Active
Travel
England

Binley Road to University Hospital route; Clifford Bridge Road Section

Design review feedback: ATE00676 Binley Road Coventry to University Hospital route

Binley Cycleway - Clifford Bridge Road

Final Layout

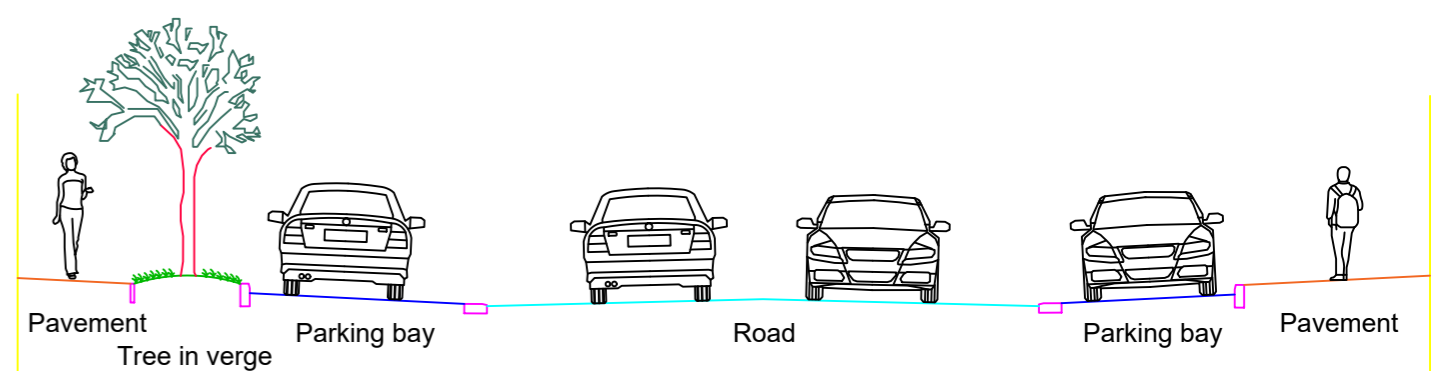
3	Length of scheme	V4.1 26Oct23	Confirmation required that a 0.5m buffer can be achieved between cycle track and parking bay.	confirmation required	Buffer provided between cycleway and parking spaces. However, it is unclear in some locations if this is provided via a kerb or road markings - i.e. it may be easy for vehicles to encroach into the buffer and reduce the buffer width. Bus stop bypasses provided on the NB carriageway. Limiting horizontal separation to 0.5m may negatively impact the comfort of cyclists riding contraflow to general traffic.	Refer to updated Binley Cycleway Section 7 - Clifford Bridge Road. Final Layout (January 2024) Proposed typical detail showing parking and driveway accesses - plan view		Yes. It was noted during the Design Review Panel workshop that the buffer will be a mix of kerbed and road markings. Markings are to be proposed where the cycleway is adjacent to parking bays and accesses, as shown on the proposed typical detail. Amber rating as the buffer proposed is non-conventional and it still likely that cars could be parked closer or on the cycle route.

7	adjacent to parking bays	V4.1 26Oct23	Could we use bollards to prevent people squeezing into this space and overhanging onto cycle track?	minor amendment	Suggest QRA pot allows for changes to scheme to rectify issues identified post-implementation.	This will be investigated at the next stage of the design but this might not be possible due to driveway access points.		Yes. It was noted during the Design Review Panel workshop that the buffer will be a mix of kerbed and road markings. Markings are to be proposed where the cycleway is adjacent to parking bays and accesses, as shown on the proposed typical detail. Amber rating as the buffer proposed is non-conventional and it still likely that cars could be parked closer or on the cycle route	
	8	adjacent to parking bays	V4.1 26Oct23	We welcome the approach to providing a buffer on the outside of the constrained width car parking bays.	none		CCC noted within the Design Review workshop that the current proposed "buffer" between parking bays and general traffic lane is 0.5m wide. However, there is potential of increasing the width at certain locations.		Yes
